Kerosene Vale Stage 2 Ash Repository Area Submissions Report

June, 2008

Delta Electricity

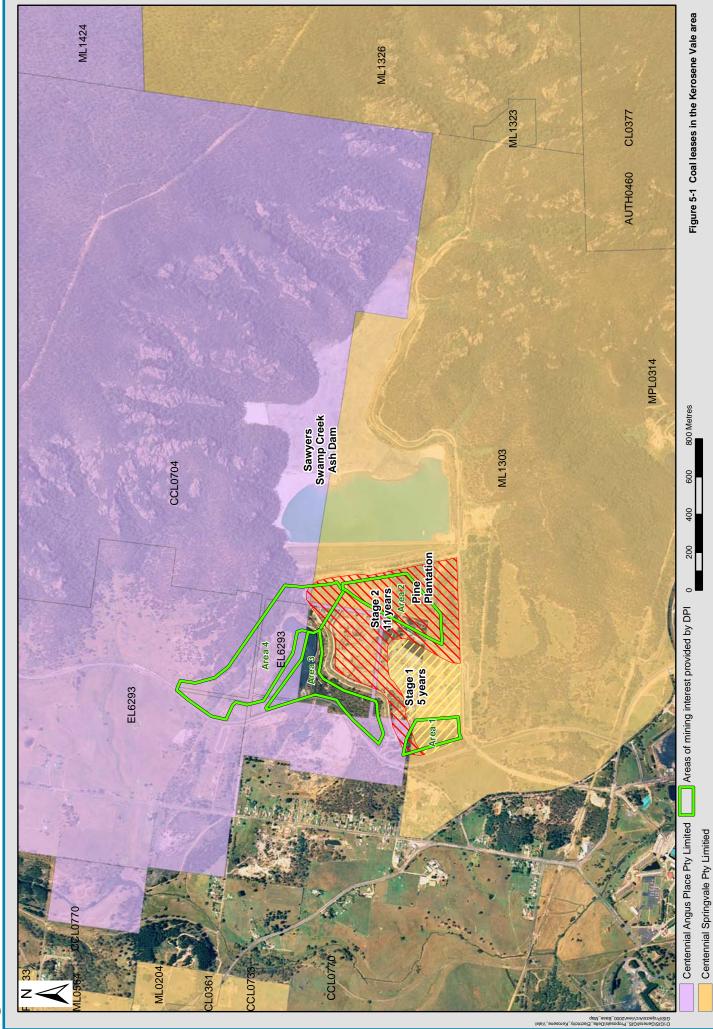
If unmitigated, the extension of the ash repository poses a significant threat to extraction of coal resources in Centennial Coal's lease/title areas.

Figure 3-1 identifies four areas that potentially contain viable coal reserves, each of which are addressed below.

Delta Electricity is currently working with Centennial Coal to address the issue of potential coal sterilisation. In response to this submission, Delta Electricity has undertaken several meetings with Centennial Coal to discuss modifications to the placement staging within its own operational constraints to enable Centennial Coal to seek a separate approval for the removal of coal resources.

In this respect, Delta Electricity reconfirms its commitment to stage the operation of the proposed Stage 2 facility (pending approval) to provide time for Centennial Coal to undertake the investigations and seek relevant approvals for extraction of coal resources remaining in the project area, subject to satisfying Delta Electricity's operational requirements as stated in the Environmental Assessment.

Additionally, Delta Electricity now proposes to postpone the realignment of Sawyers Swamp Creek to allow Centennial Coal as much time as possible to access areas identified in its submission and shown in Figure 3-1. Further detail on the proposed modifications to the project is provided in Chapter 5.

Areas 3 and 4 would primarily be affected by the proposed creek realignment. Delta Electricity, as a result of this submission, now plans to realign the creek in late 2010, in order to allow Centennial Coal time to seek approval to mine this area and to identify alternate creek realignments that satisfy the environmental requirements of regulators. If Centennial Coal is successful in this application, Delta Electricity would expect Centennial Coal to undertake the creek realignment and any associated work.

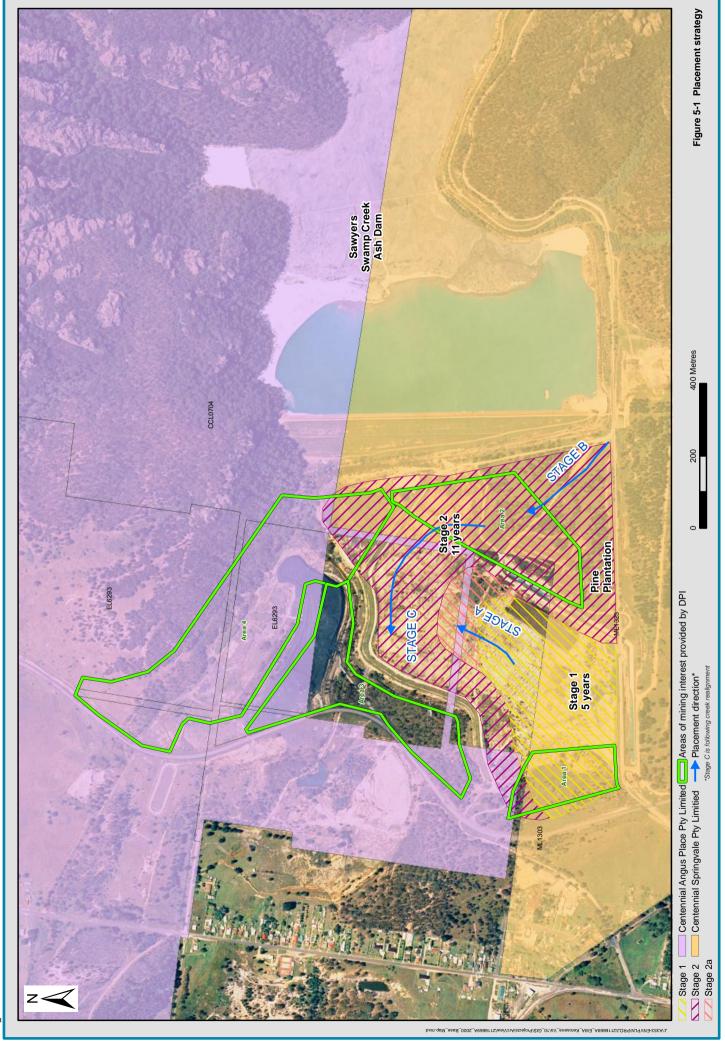
On completion of a review of the received submissions, the Environmental Assessment and overall project were reviewed. On the basis of this review, some minor modifications to the project were determined to facilitate issues raised in submissions. The review also confirmed that the proposed changes to the project would not alter the extent or nature of the overall environmental impacts as set out in the Environmental Assessment. The proposed modifications to the project include:

On the basis of the submissions received from Centennial Coal and the Department of Primary Industries in relation to potential coal reserves affected by the proposal, Delta Electricity proposes to modify its staging at the site to extend the time period before areas identified by Centennial Coal are affected. Delta Electricity believes this will provide a finite opportunity for Centennial Coal to obtain approval to extract any economically viable resources should they be successful in their application for approval.

In this respect, the placing of ash was originally proposed to head in an easterly direction from the Stage 1 area into the pine plantation area and then in a northerly direction, which would have affected the potential coal in Area 2 (see Figure 5-1). As an alternative, Delta Electricity now proposes to place ash in a north-easterly direction to the limit of what is safe within the stability constraints of the existing berm — assessed as 100 metres (Douglas Partners, 2001) — and then move to the area over the pine plantation once other areas have reached capacity. This staging would provide between 9 and 12 months for Centennial Coal to obtain the relevant approvals and commence extraction in Area 2, depending on ash production rates and power generation requirements. After this time, operational constraints would mean that ash placement over the pine plantation area would need to occur in line with the original proposal, as described in the Environmental Assessment. Areas 3 and 4 are discussed further below in relation to the revised timing of the creek realignment.

The realignment was originally proposed for early 2009, but as a result of revised staging and in the interests of facilitating an opportunity for Centennial Coal to seek approval to extract coal resources in Areas 3 and 4 (see Figure 5-1), this activity is now proposed to be scheduled for late-2010. This would allow Centennial Coal time to develop and seek approval for an alternative creek alignment to facilitate extraction activities (subject to separate approval) and avoid multiple realignments of an already degraded stream, should the proposed activities obtain approval.

To facilitate the revised staging, it is now proposed that surface water is initially directed in a southerly direction back to the existing surface water canal and the originally proposed pond once placement moves to the pine plantation (refer to Stage B on Figure 5-1). The revised surface water management and drainage is shown in Figure 5-2.
